LIBERTY KNITWEAR LTD. UNIT-2 (EXTENSION 3)

23 February 2026

2. Observation

COLUMN LAYOUT PLAN

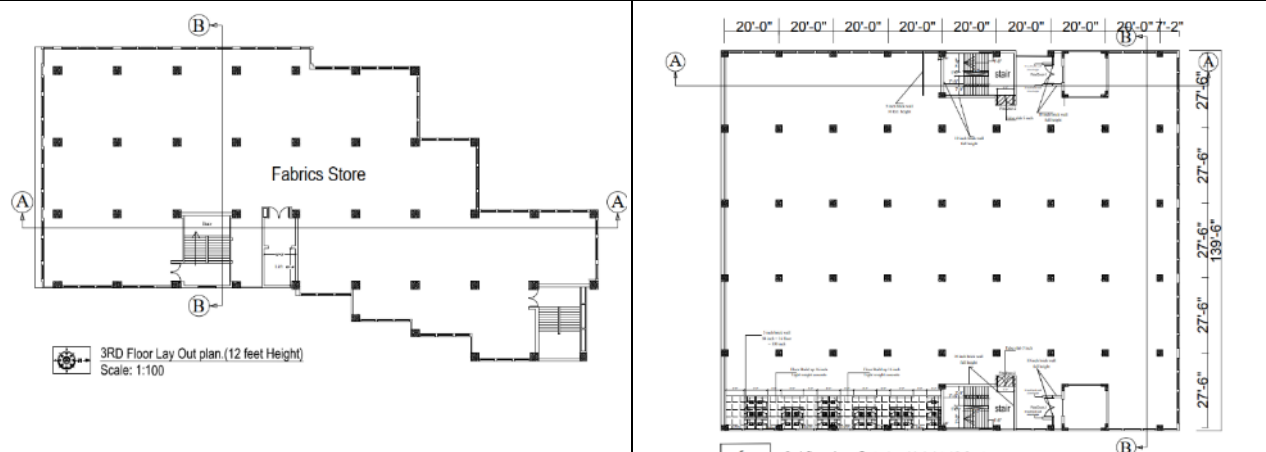
Observation-01: Stress in the column marginally above the design limit and lack of design report. (Generator Powerhouse Building & East Tower Building).

Description: The cursory calculation indicated that the columns are marginally stressed above the normal design limit, considering the prepared live load plan and minimum concrete strength due to an inadequate materials test report. The building engineer is required to review the design, load, and column stress, seismic requirements, framing system, and incorporate necessary measures (if necessary) as per section 2.5.8 (b)BNBC 2020 and update the analysis and design report in accordance with Section 1.9.1 of the BNBC.

Also, the building engineer is required to verify the concrete strength by taking cores (100 mm dia at least 4 nos) from the column, beam and slab for each building.

Item No	Observation	Action Plan	Timeline
1.	Stress in the column marginally above the design limit and a lack of design report (Generator Powerhouse Building)	Building engineer is required to review the design, load, and column stress, seismic requirements, framing system, and incorporate necessary measures (if necessary) as per section 2.5.8 (b)BNBC 2020 and update the analysis and design report in accordance with Section 1.9.1 of the BNBC.	within 6 weeks

2.		Verify the concrete strength by taking cores (100 mm dia at least 4 nos) from the column, beam, and slab.	within 6 weeks
3.		Implement remediation work if required.	within 6 months

9.	Stress in the column marginally above the design limit and a lack of design report (East Tower Building)	Building engineer is required to review the design, load, and column stress, seismic requirements, framing system, and incorporate necessary measures (if necessary) as per section 2.5.8 (b)BNBC 2020 and update the analysis and design report in accordance with Section 1.9.1 of the BNBC.	within 6 weeks

10.		Verify the concrete strength by taking cores (100 mm dia at least 4 nos) from the column, beam, and slab.	within 6 weeks
11.		Implement remediation work if required.	within 6 months
